ENVIRONMENTAL REVIEW TEAM REPORT

REGION #15 SCHOOL SITE
MIDDLEBURY, CONNECTICUT

DECEMBER 1979

FIGURE 2.
SIMPLIFIED SITE PLAN

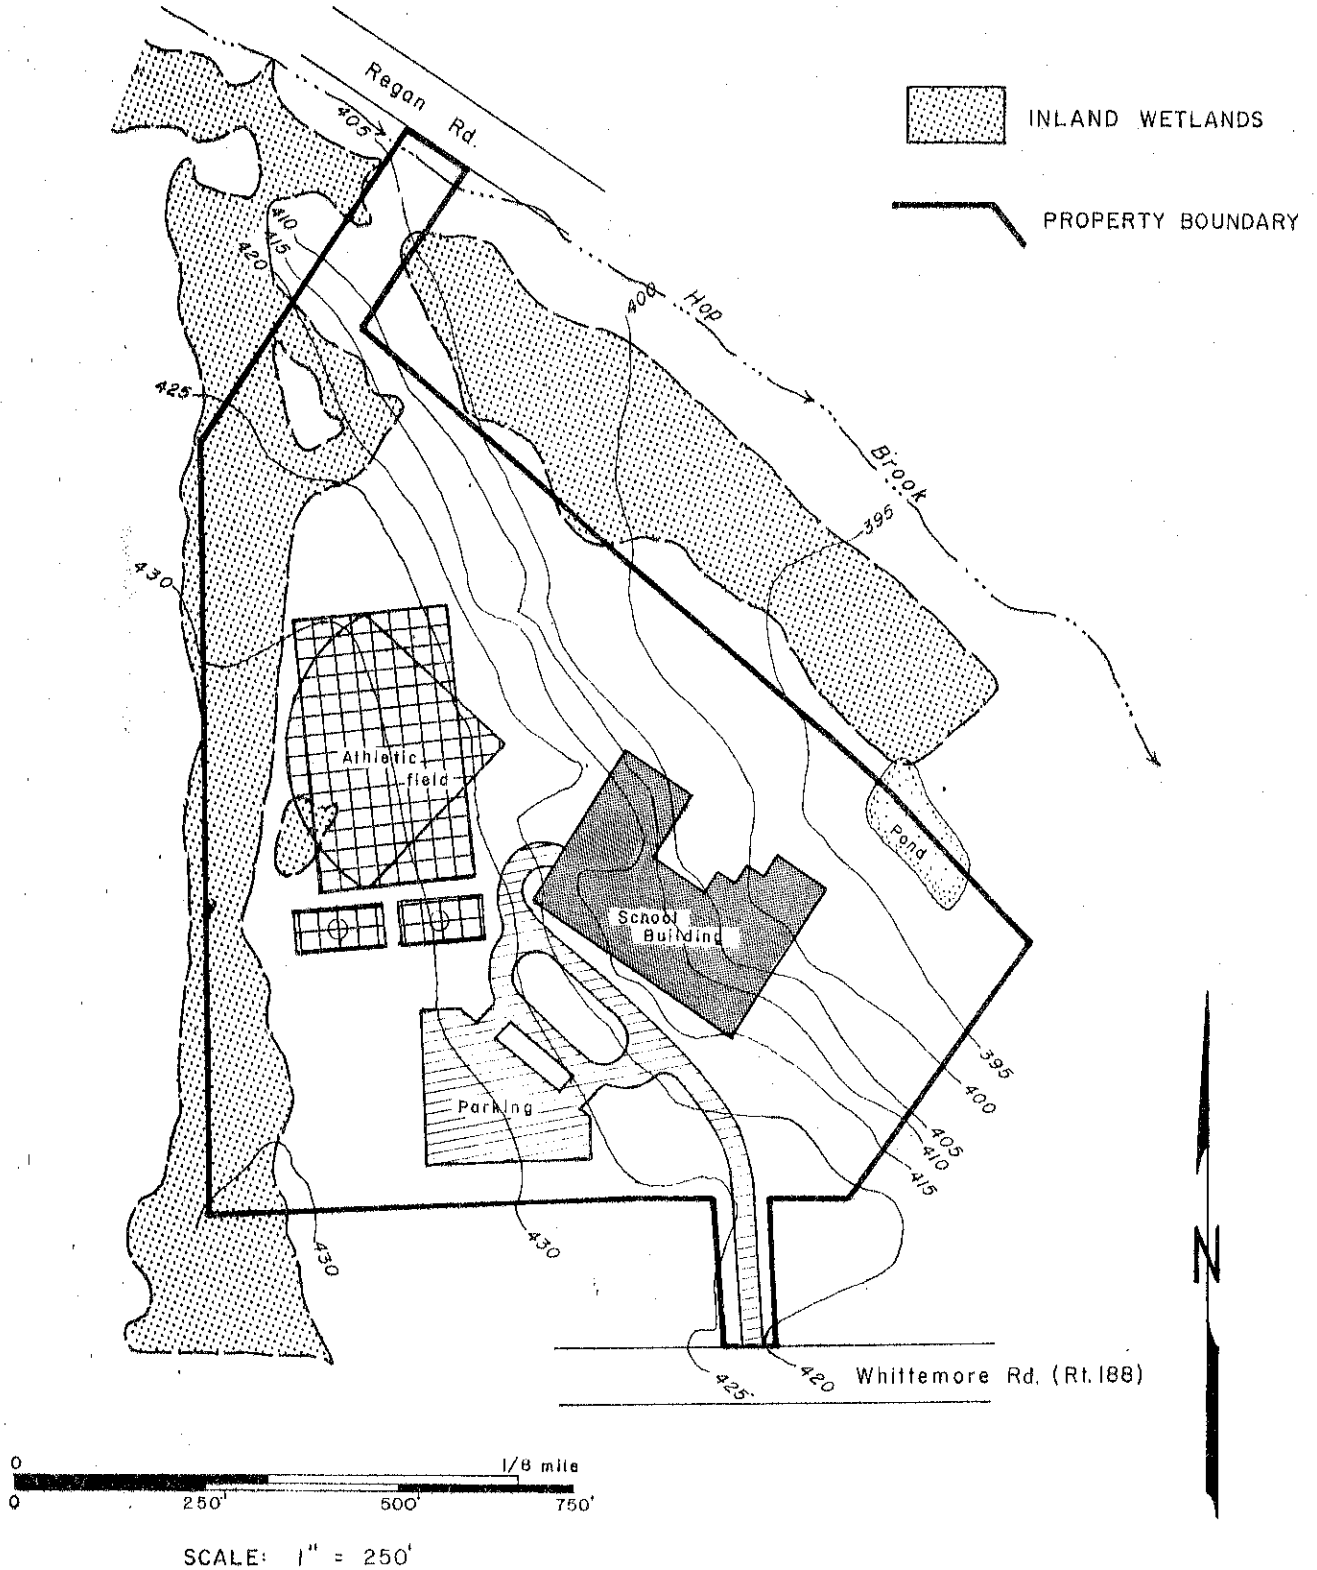
The preliminary site plan for the project, shown in Figure 2, calls for the construction of a school building, access road and parking lot, two play areas, and an athletic field. The school would be designed for a capacity of 500 students, according to the Superintendent of Schools for District #15. The proposed project would be served by on-site wells and public sewers.

The latest revisions of the site plans (dated 10/23/79) are much more acceptable than previous plans submitted. Many of the problems associated with previous plans are no longer valid, particularly with respect to wetlands impact. Under the current plan, a minimal amount of wetlands will be intruded upon. Providing suitable plans are made for stormwater control, the project should not significantly affect the wetlands on or adjacent to the site.

FIGURE 3.

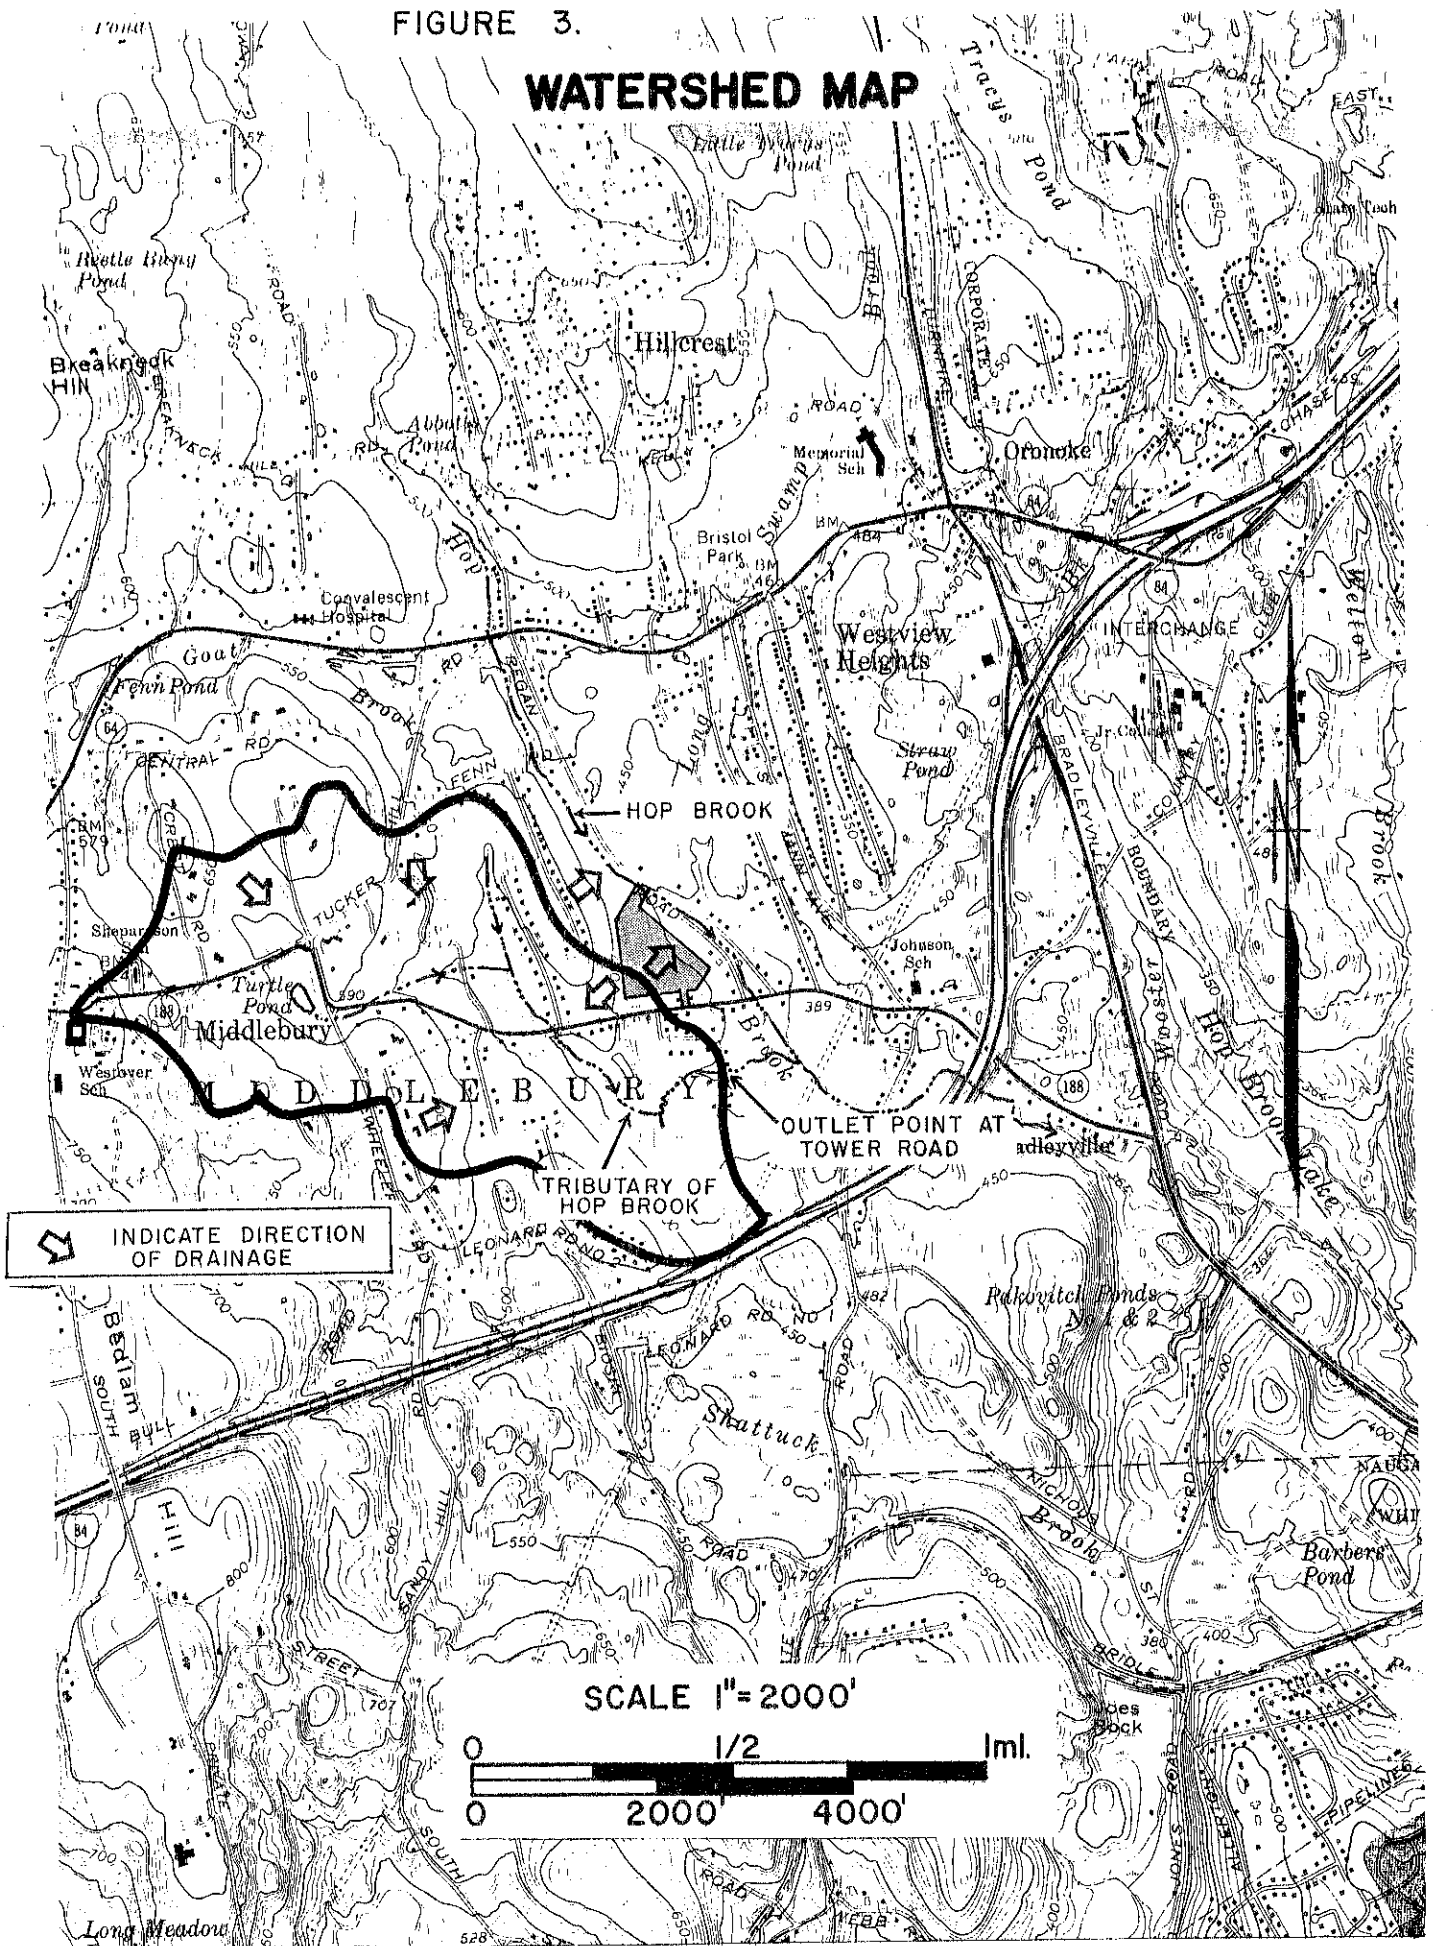
Drainage from the southwestern corner of the property collects in a small depression adjacent to Whittemore Road, and from there flows southerly underneath the road toward a tributary of Hop Brook. Drainage from the rest of the site flows more or less directly into Hop Brook (see Figure 3). Although the proposed school development would cause an increase in runoff from the site, it would have a negligible effect on flows in Hop Brook since the brook has an extensive drainage area (several square miles) upstream from the site.

It was unclear from the field review whether the small area draining southward from the property is piped under Whittemore Road or whether it simply flows through the road fill. The drainage swale south of Whittemore Road leads to a tributary of Hop Brook that flows through a culvert under Tower Road, approximately 1000 feet southeast of the site. Flooding problems from this tributary have occurred recently on Tower Road and have been discussed in an earlier report of the King's Mark Environmental Review Team (Woods Hill and Conton Drive Subdivisions). In that report, it was suggested that the town keep a close watch on future development within the tributary's watershed to prevent aggravation of these flooding problems. The overall effect of the proposed facilities on peak flows in the Hop Brook tributary would depend on the types of engineering measures that are used. For instance, placement of a culvert under Whittemore Road (or clearing of the culvert if one presently exists) would allow more rapid drainage from the depression area southward. Natural drainage from the area to be developed, however, accounts for only two percent of the watershed of the tributary to the culvert on Tower Road. The effect of a new or improved culvert on Whittemore Road should therefore be small if natural drainage patterns are not significantly disturbed. However, if parking lot drainage were channeled to the Whittemore Road culvert or if final grading caused an

effective increase in the contributing area north of Whittemore Road (that is, if more of the site were graded to slope southward rather than eastward), an appreciable effect on peak flows in the tributary could result. Hence, it is recommended that drainage from the site be channeled and land graded primarily in an easterly direction to take advantage of the greater buffering capacity of Hop Brook's larger flows.

FIGURE 4.
VEGETATION MAP

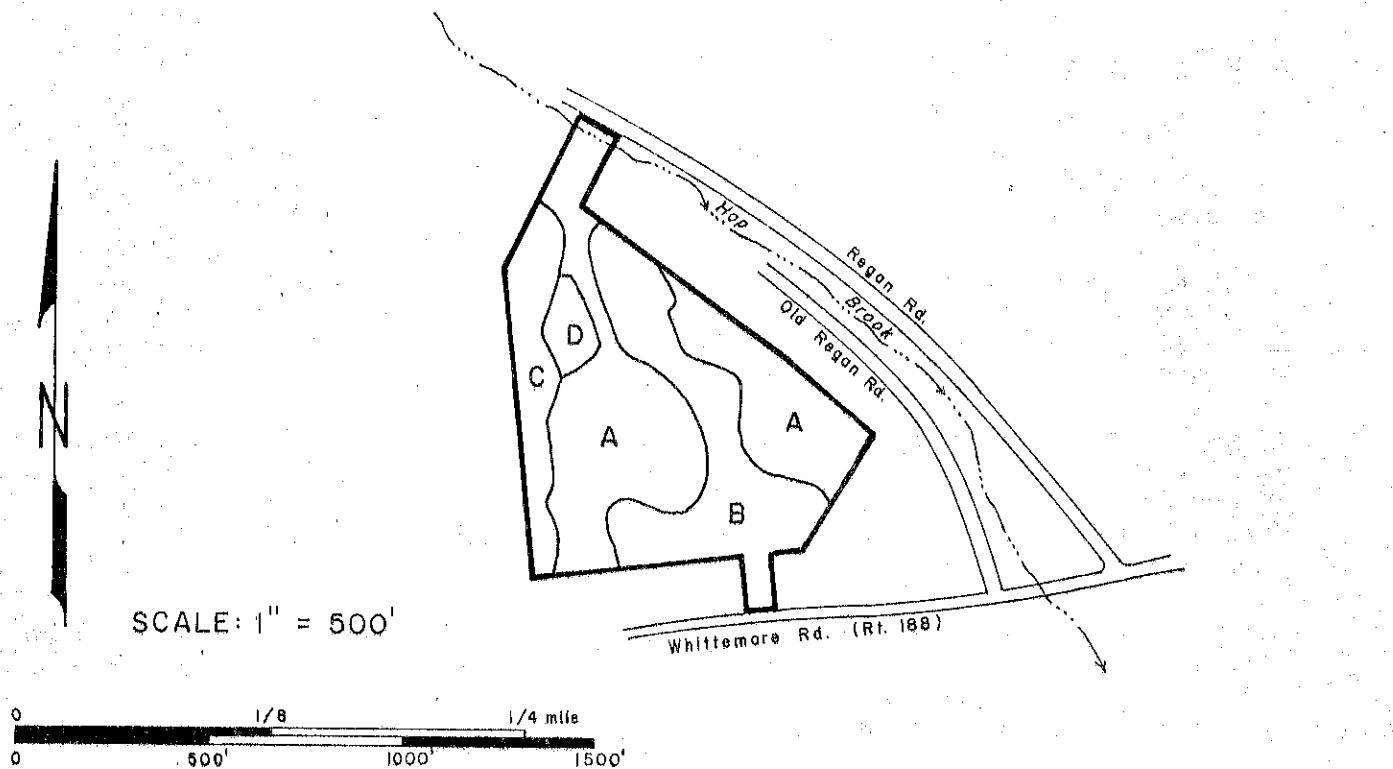
The permanently high water table and poor soil aeration in Stand C (hardwood swamp) limits vegetation growth to species that can tolerate excessive moisture conditions. Early crowding of the red maple and white ash which are able to survive under these conditions has resulted in trees which are presently slow growing, tall and small crowned.

The soils in Stand B (specifically the Hollis part) are shallow to bedrock. The shallowness of this soil limits moisture reserves for plants and also restricts the depth of tree root systems. These conditions cause the trees present to be slow growing and widely dispersed.

Windthrow is a potential hazard in the hardwood swamp (Stand C). As a result of the high water table, the trees present in this stand are extremely shallow rooted and unable to become securely anchored. The tallness and crowded condition of the pole-size trees in this stand increases the potential for windthrow. At present these trees rely on each other for stability. If linear openings are made in, or right along side, this stand, the windthrow hazard may be increased. Any openings, which would allow wind to pass through rather than over this stand, should be avoided if at all possible.

The trees in Stand A (mixed hardwoods) are crowded; this condition is starting to cause a general decline in tree health and vigor. A thinning in this stand, removing approximately one-third of the total volume will reduce competition between residual trees for space, light, water and nutrients. Over time, the trees remaining in this stand will respond by becoming healthier and more stable. This fuelwood thinning should be focused on removing poor quality trees, damaged trees, and those trees that are directly competing with high quality desirable trees. This thinning, if implemented, will produce between four and five cords of fuelwood per acre. A publicly employed service forester could be contacted if further assistance is desired.
